**Integra Underground Project (MP 08_0101)
Extraction Plan for Longwalls 17-20**

Consideration of Approval of Extraction Plan for Longwalls 17-20

Figure 1 - Surface features in proximity to LWs 17-20

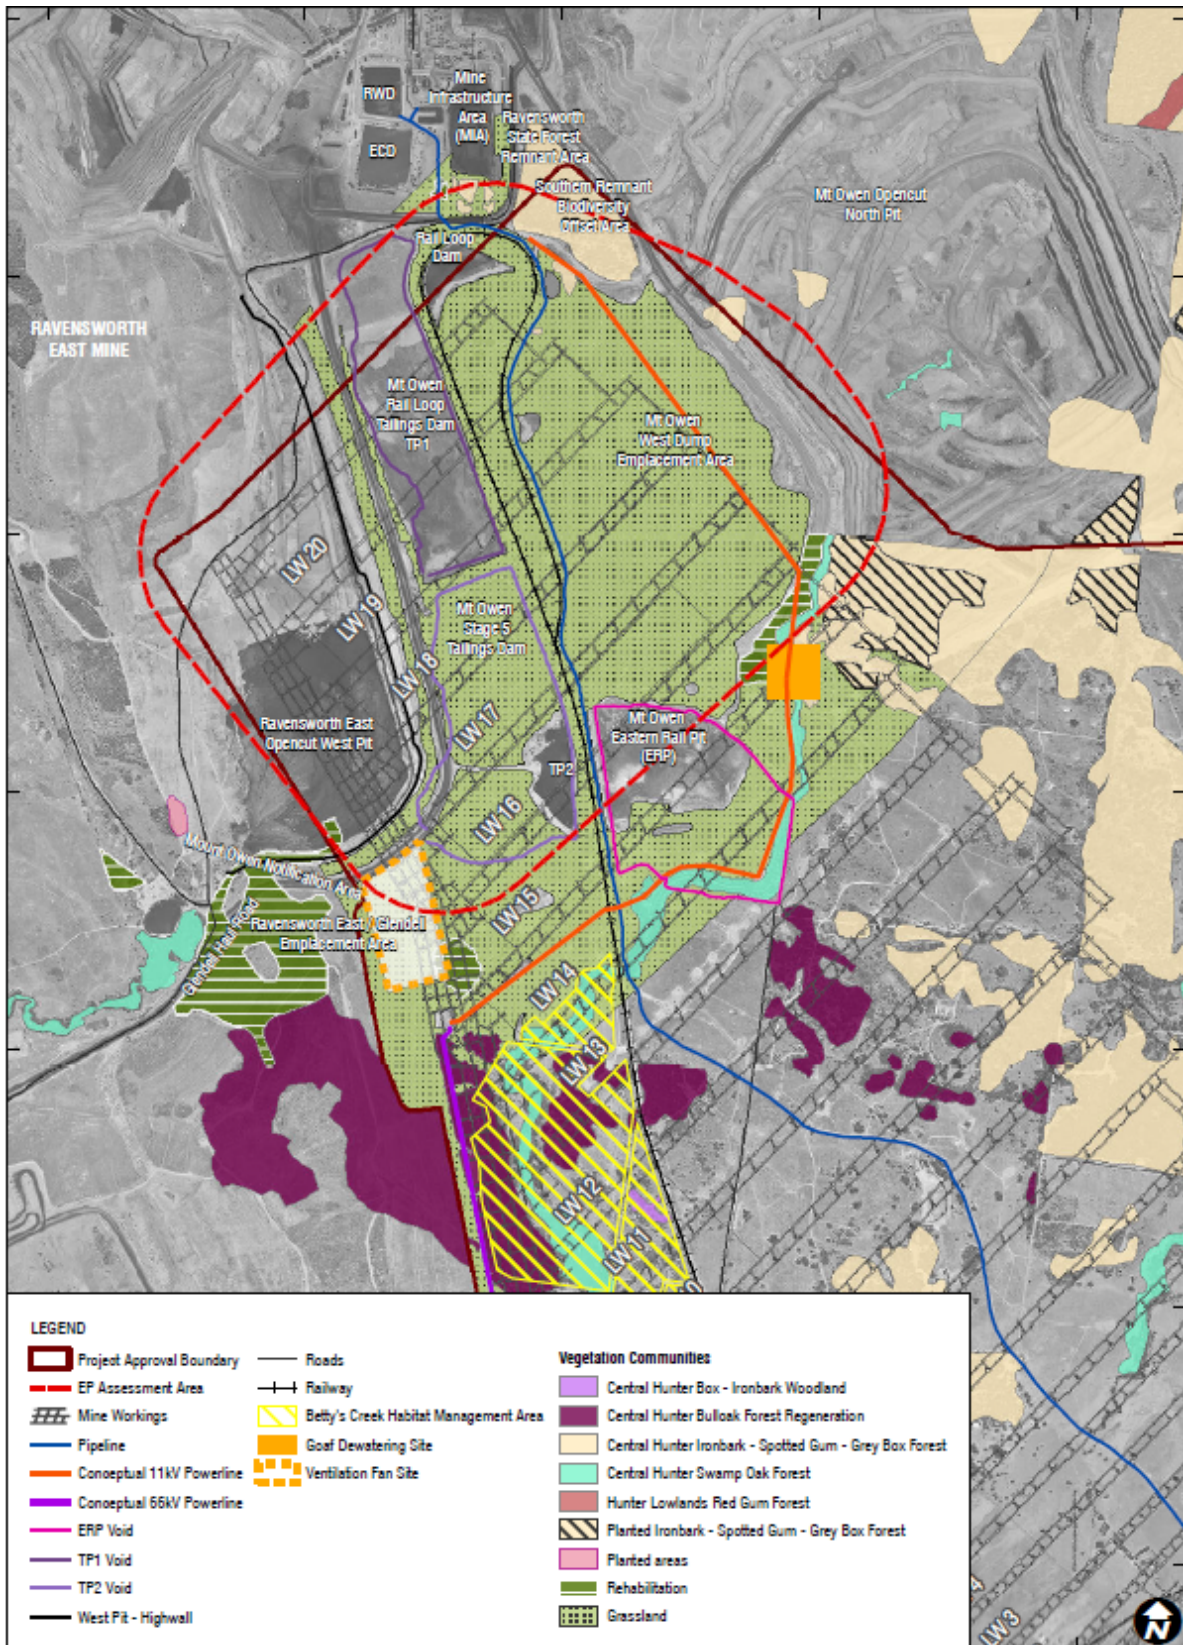
14. Key surface features overlying LWs 17-20 are shown in **Figure 1**. Subsidence impacts would be limited to approved disturbance areas associated with the Mount Owen Continued Operations Project (SSD 5850). The subsidence zone for LWs 17-20 contains rail infrastructure, dams, a coal conveyor, haul roads, transmission lines and overburden emplacement areas associated with open cut mining at the Mount Owen Complex. The Mount Owen Complex is also owned by a subsidiary of Glencore.

21. The Mount Owen Rail Loop Tailings Dam (shown in **Figure 1**) is a declared dam under the *Dams Safety Act 2015*. The SA indicates that strains in the vicinity of the dam would be less than 4 mm/m and be imperceptible. Nonetheless, HVCC has committed to regular monitoring and management of any ponding to reduce the risk of overflow and will obtain all necessary approvals from Dams Safety NSW prior to undermining the dam.
